# BDS Checksheet Response

## Structural Checksheet Response

Permit #: 14-251964-000-00-CO

JHI Job No.: 13-0283 Page 1 of 2  
Date: FEB 2015  
Project: FOAM TANK  
Client: ARC TERMINALS  
By: JLP Dept.: STRUCTURAL  
Design Item: FIRE FOAM SKID ANCHORAGE  
REV 1 RESPONSE TO STRUCTURAL CHECKSHEET

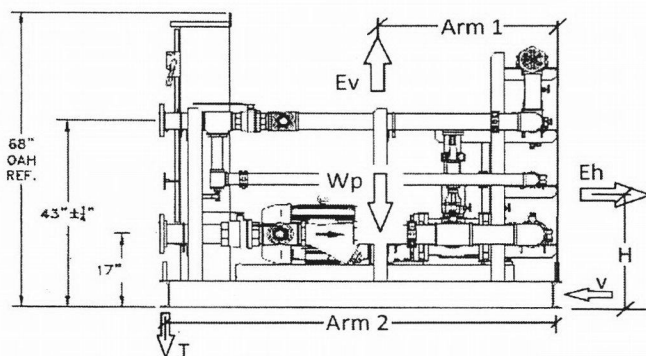
#	Description of changes, revisions, additions, etc.	Checksheet and item #
1	Please see the attached completed special inspection form. The Statement of Special Inspection is shown on sheets S012 and S013. The stages requiring structural observation are listed in Division 1.E Structural Observations on drawing S010.	Structural #1
2	The foam tank will be added to the deferred submittal list on drawing G001. Once we have reviewed and approved the deferred submittals from the contractor, the deferred submittals will be submitted to the City of Portland for review and approval.	Structural #2
3	See revision 1 on S301 tank data was added per note 7 & 8. See revision 1 on G001 foam tank added as deferred submittal.	Structural #3
4	See revision 1 on S301 pump skid weight was added per note 9. See revision 1 on S305 section V for skid anchor size & number. See additional calculations Fire Foam Skid Anchorage on pages 1 of 2 and 2 of 2.	Structural #4

OTM =  $E_h \times H = 3,331 \text{ ft-lb}$

RM =  $0.9 W_p \times (\text{Arm 1}) = 14,333 \text{ ft-lb}$

OTM SF = 4.30 T=0 no uplift

Per anchor =  $V/4 = 416 \text{ lb per anchor}$

Use: 1/2" diameter threaded rod set in Hilti-Hit RE 500 adhesive embed 4" minimum into concrete.  
See Hilti Profis for calculation
